CSWA2-63DR+ PCN Report

AN-80-009

As a result of obsolescence of the original dice, the re-design effort includes the use of a new set of dice in existing package maintaining existing PCB footprint. The replacement dice has been judged by Mini-Circuits Engineering as a suitable replacement for the existing CSWA2-63DR+.

CASE STYLE: DG1293: No Change

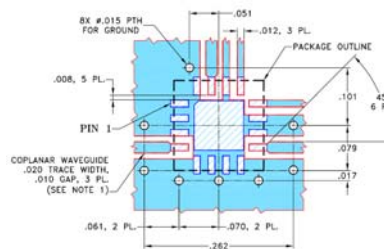
Suggested PCB drawing: No Change

COMPARISON PERFORMANCE CURVES^a:

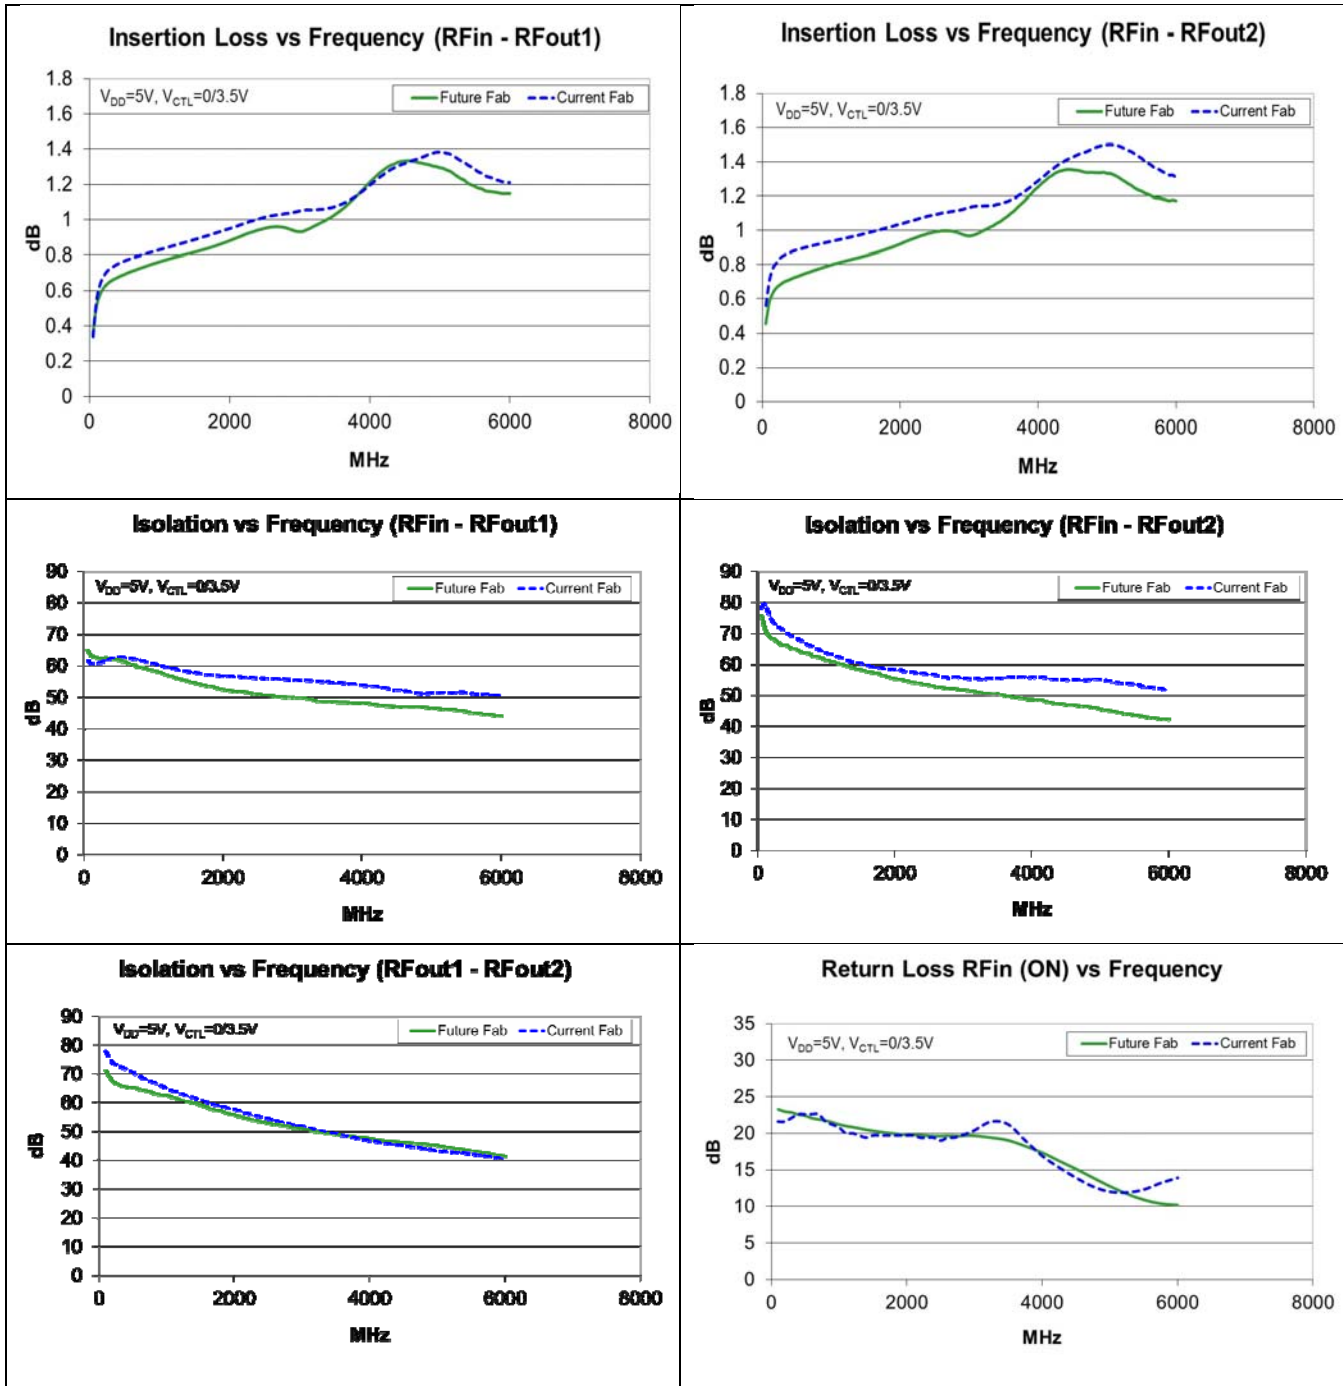
- 1) **FORM-FIT-FUNCTIONAL COMPATIBLE₃**: Form & FIT Compatible with minor Functional Changes as follows:

ORIGINAL PART: CSWA2-63DR+	REPLACEMENT PART: CSWA2-63DR+
<p>Control Voltage High: 2.7V min, V_{DD} max</p> <p>Supply Current ($V_{DD} = 5V$): 18uA typ</p> <p>Isolation between common port and RF1/RF2 ports</p> <ol style="list-style-type: none"> 1) 54dB min, 70dB typ at 500-2000MHz 2) 50dB min, 60dB typ at 2000-3000MHz 3) 50dB min, 54dB typ at 3000-4000MHz <p>Isolation between RF1 and RF2 ports</p> <ol style="list-style-type: none"> 1) 76dB typ at 0.3-500MHz 2) 64dB typ at 500-2000MHz 3) 50dB min, 54dB typ at 2000-3000MHz 	<p>Control Voltage High: 2.7V min*, V_{DD} max</p> <p>*$V_{DD} = 3$ to 4V, Control Voltage High = 2.7V min $V_{DD} = 4$ to 5V, Control Voltage High = 3.5V min</p> <p>Supply Current ($V_{DD} = 5V$): 50uA typ</p> <p>Isolation between common port and RF1/RF2 ports</p> <ol style="list-style-type: none"> 1) 50dB min, 60dB typ at 500-2000MHz 2) 47dB min, 52dB typ at 2000-3000MHz 3) 45dB min, 50dB typ at 3000-4000MHz <p>Isolation between RF1 and RF2 ports</p> <ol style="list-style-type: none"> 1) 70dB typ at 0.3-500MHz 2) 60dB typ at 500-2000MHz 3) 47dB min, 52dB typ at 2000-3000MHz
